TECHNICAL INFORMATION JDE

Type Coffee Vending Machine	Model 9100	T.I. NO 02 - 2017	
Serial Number 71211404	Subject Modification of 250VA SWITCHING POWER BOARD	ISSUED FOR (X)	Action Information <input checked="" type="checkbox"/>

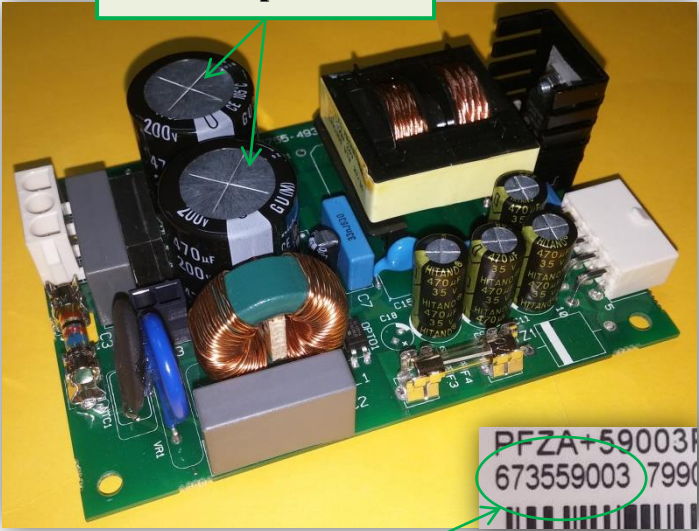
Be informed that with the aim to improve our equipment, the **250 VA switching power board** has been modified.

The **two capacitors** have been modified.

New
250VA switching power board
Spare part code: **261184**

Pre-modification
250VA switching power board
Spare part code: **256350**

New capacitors

Pre-modification capacitors

➤ **Machines concerned by modification from S/N 71211404**

The *new power board* can be installed in the machines prior to the above mentioned S/N.
